# Wisconsin Department of Transportation

**Proposal #41: 8760-00-70, WISC 2019 763**  
**Oliver - Superior**  
**Pokegama River Bridge B-16-0143**  
**STH 105**  
**Douglas County**

This is Addendum No. 01, which provides for the following:

**Addendum No. 01  
ID 8760-00-70  
Revised Sheet 2  
December 5, 2019**

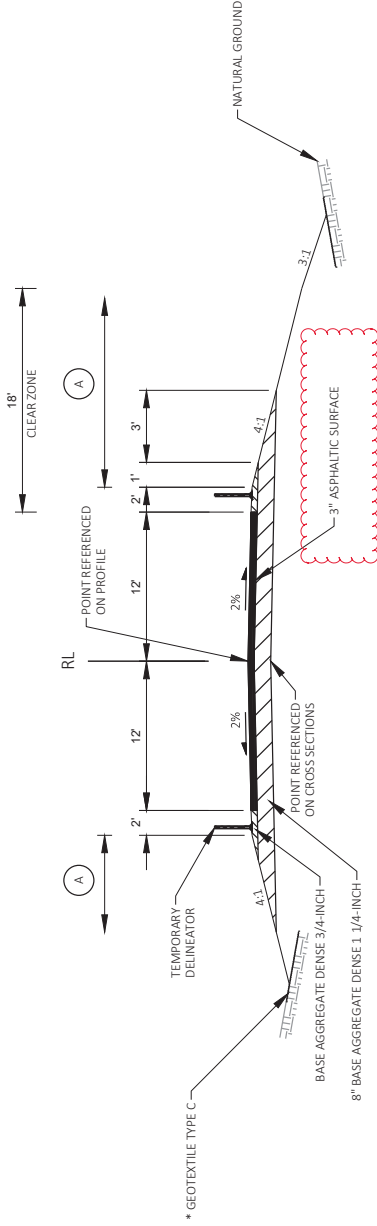
Revised Plan Sheets	
Plan Sheet	Plan Sheet Title (brief description of changes to sheet)
2	General Notes -- text change from HMA Pavement 3MT 58-28- S to Asphaltic Surface
4	Typical Section -- text change from HMA Pavement 3MT 58-28 S to Asphaltic Surface
18	Misc. Quantity -- remove quantity HMA 3MT 58-28 S and revise Asphaltic Surface

- MANHOLE HMA PAVEMENT SHALL CONSIST OF 5.75-INCHES, TWO 2-INCH 4MFT 58-28S LOWER LIFTS, AND A 1.75-INCH 4MFT 58-34S UPPER LIFT.
- BYPASS HMA PAVEMENT SHALL CONSIST OF A 3-INCH ASPHALTIC SURFACE LIFT.
